DFCM Addendum #1

Reference: MTECH Provo – Phase 5B - Practical Nursing
 DFCM Project #18207260
 U3P Event #CS26018

ADDENDUM NO. 1

**MTECH Provo Phase VB
Practical Nursing
DFCM Project #18207260**

LEVEL 3 REFLECTED
CEILING DEMO PLAN

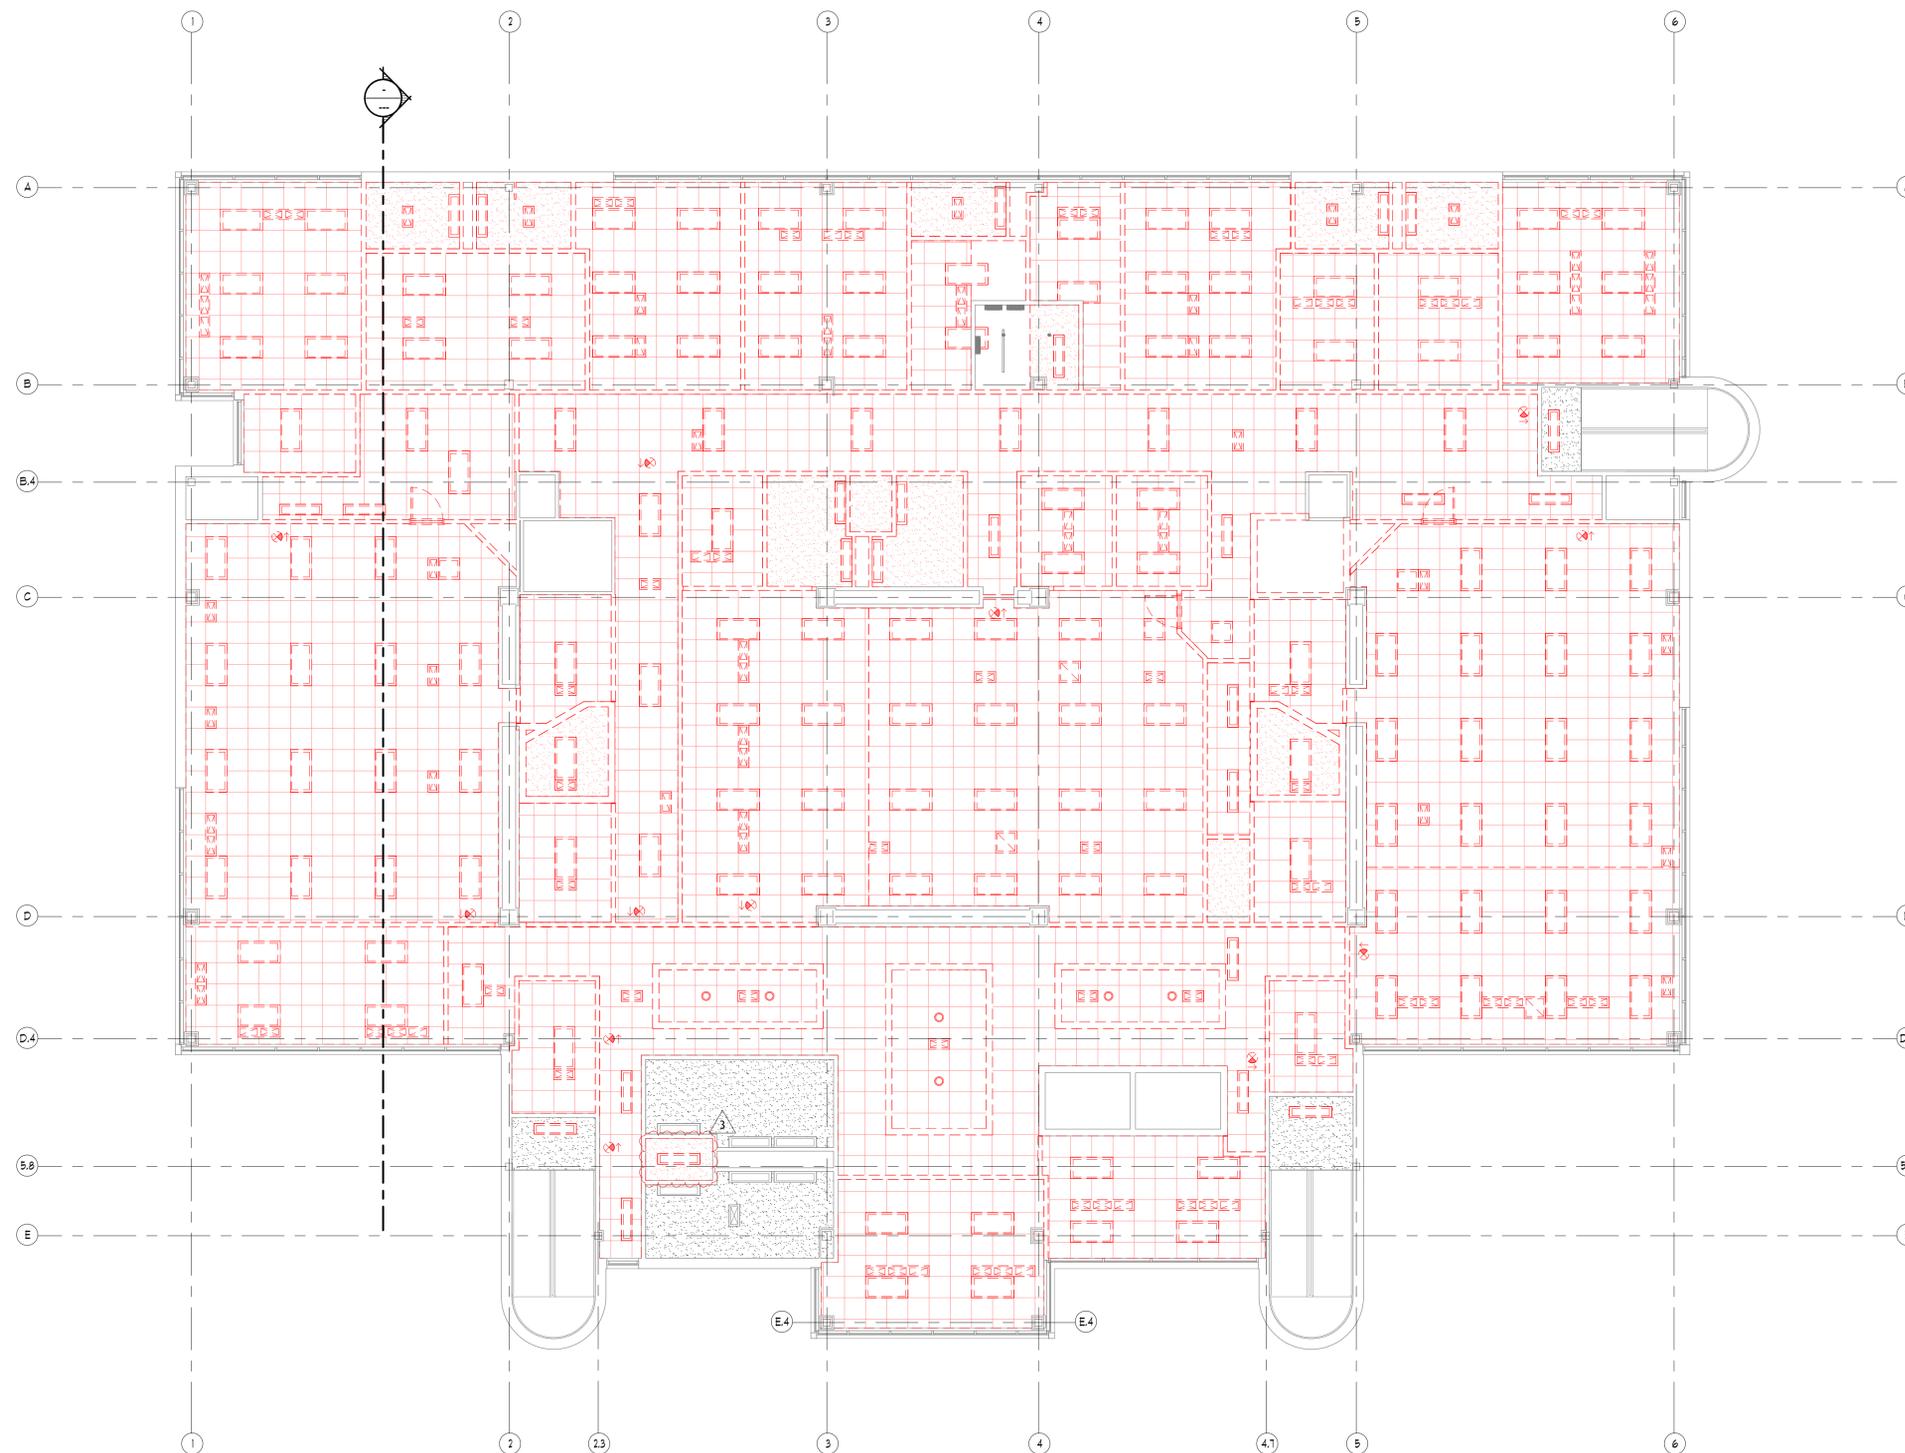
70. Question: A8.1 and A8.2 Reflected ceiling demolition shows the South East restroom ceilings to remain. The mechanical plans show demolition of some ducting and new ducting and diffusers into these Hard lid restrooms Please clarify what work is happening here. There is a conflict currently. Response: The mechanical design has been updated to reduce the impact to the above ceiling space, with access provided by removing the ceiling in the adjacent Janitor (305) and providing a 2 x 2 acoustical ceiling. See response provided by

10. Sheet A8.1: Ceiling over Janitor (305) shown to be removed.
11. Sheet A8.2: Ceiling over Janitor (305) updated from "existing" to "ACT-1".
12. Sheet A9.1: Sheet notes updated. "DC" added to Accessory Abbreviations.

1 LEVEL 3 PLUMBING DOMESTIC DEMOLITION PLAN
3/16" = 1'-0"

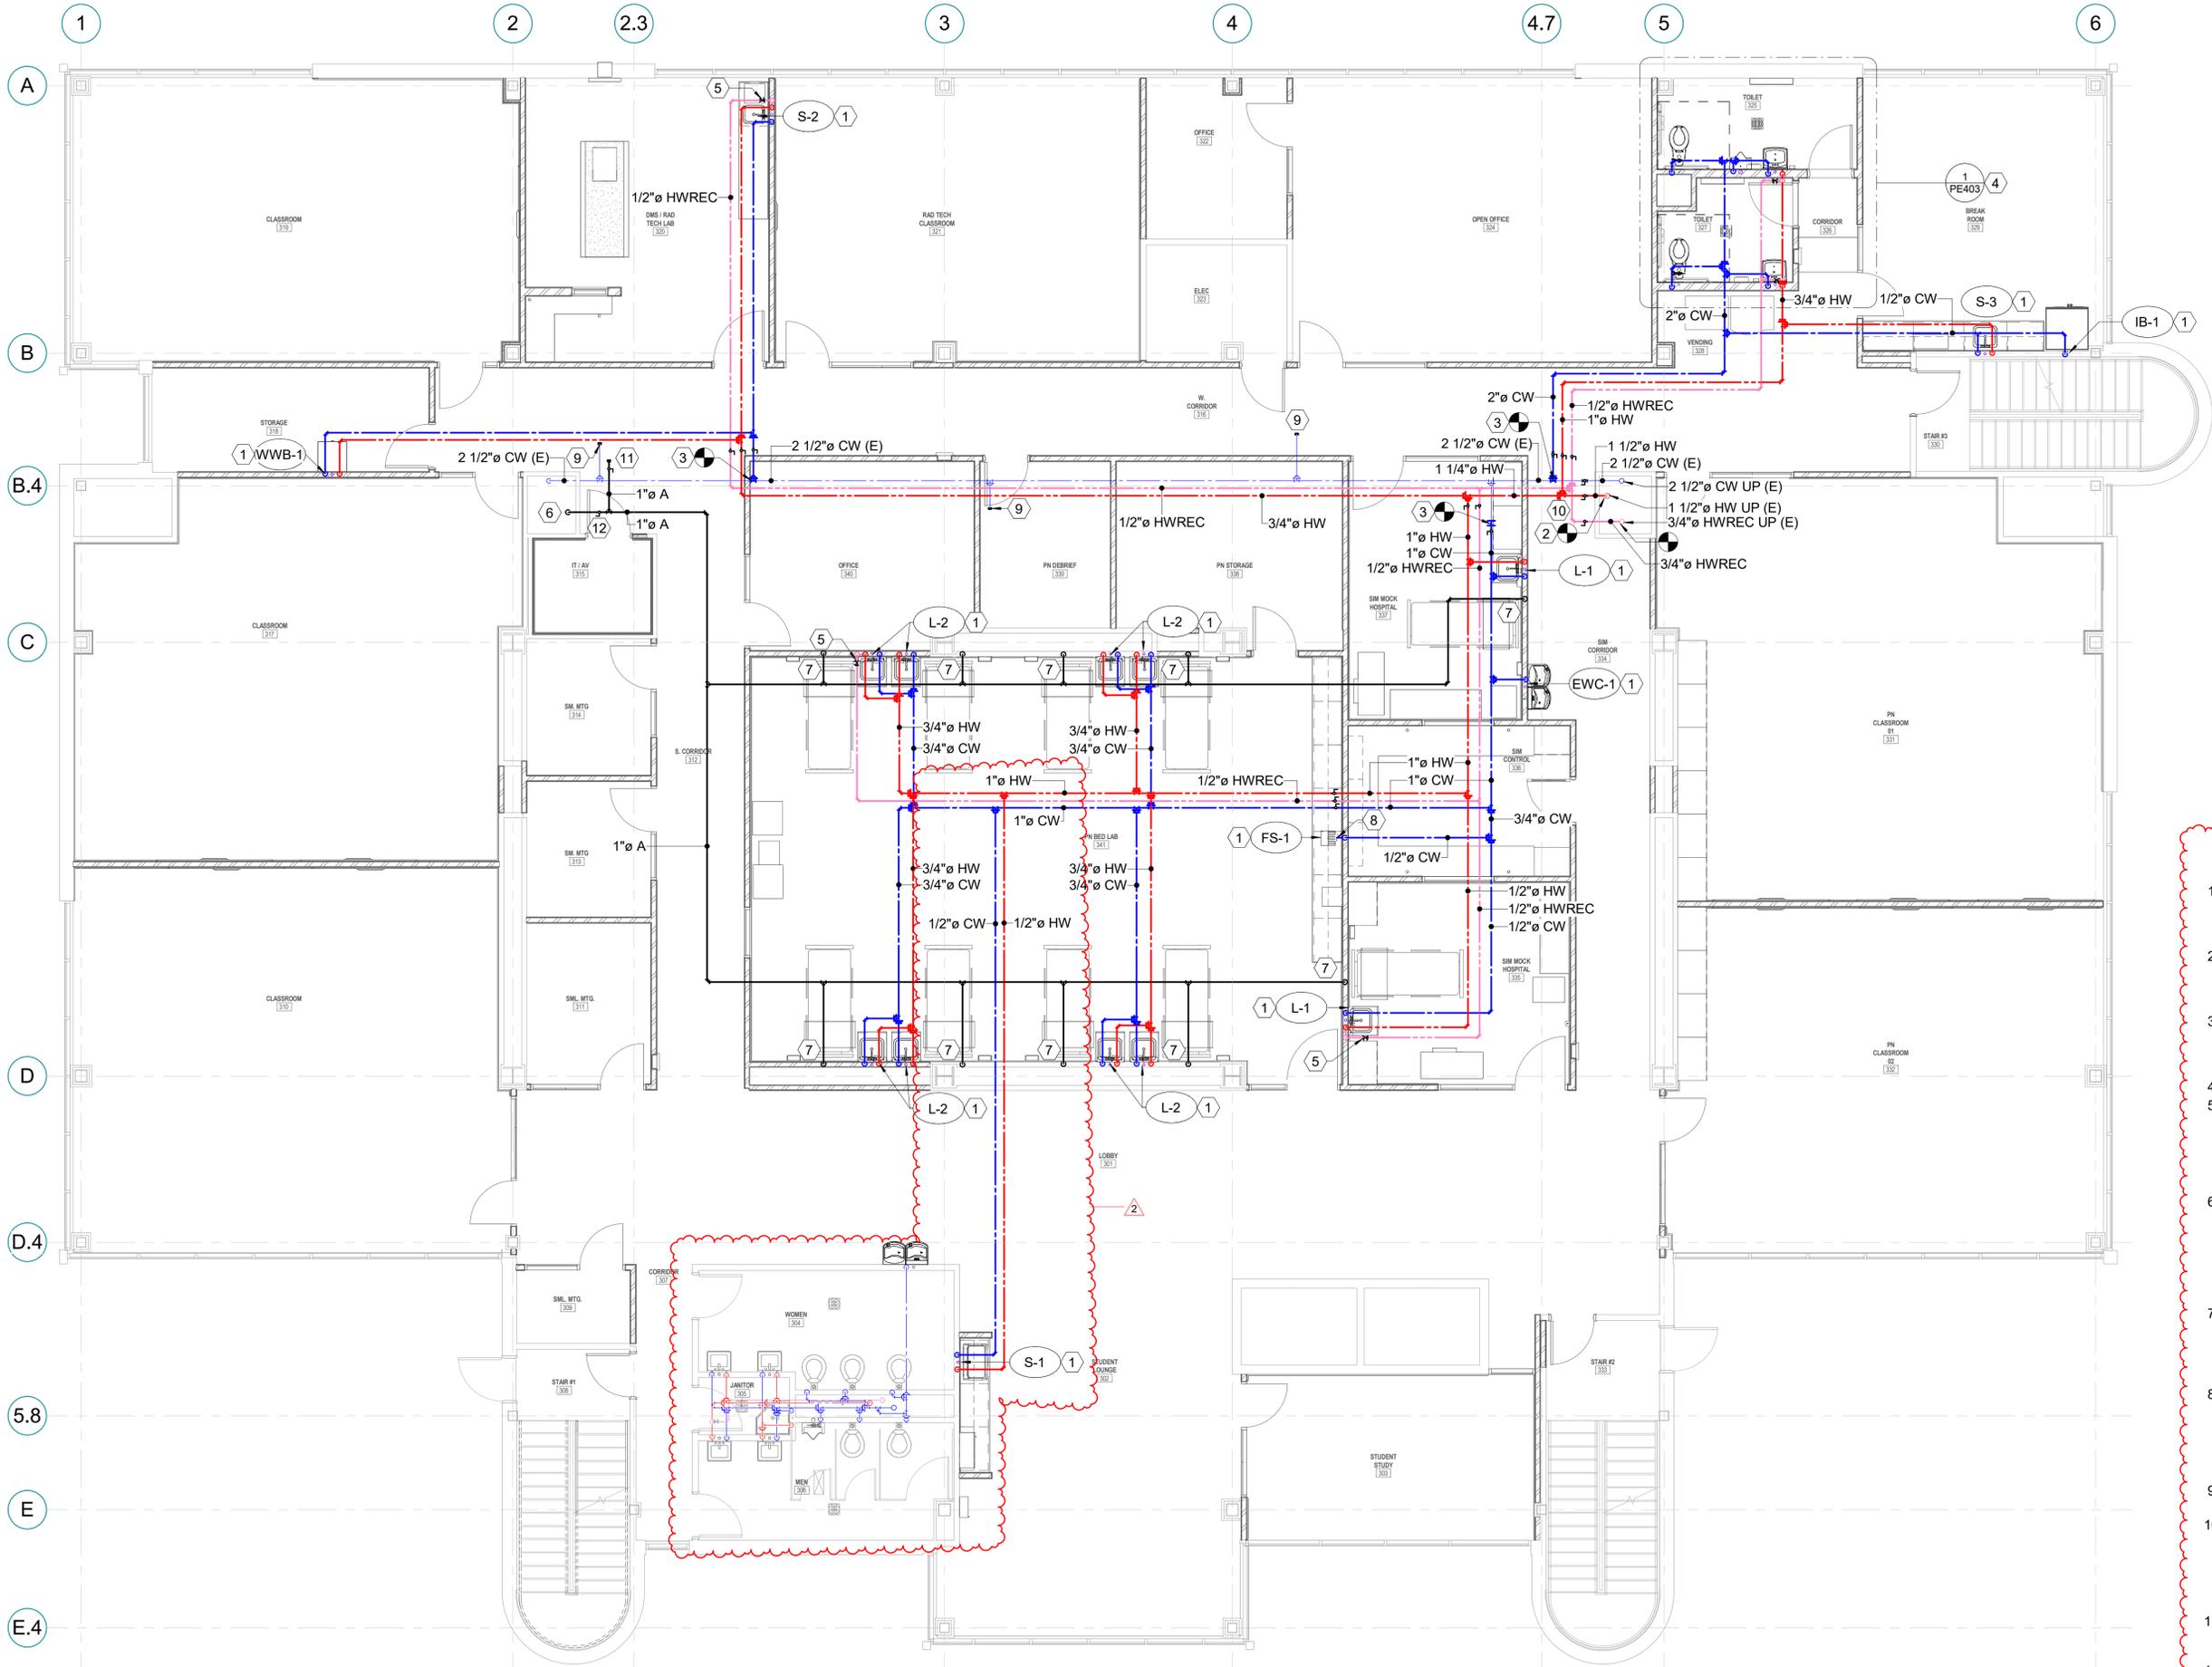
73. Question: PD103.1, PD103.2, PE103.1 and PE103.2 show plumbing work above the existing restroom hard lid ceiling that is called to remain. Please clarify scope of work and conflict. **Response: Plumbing to that sink has been routed from another location. See response provided by WHW Engineering.**
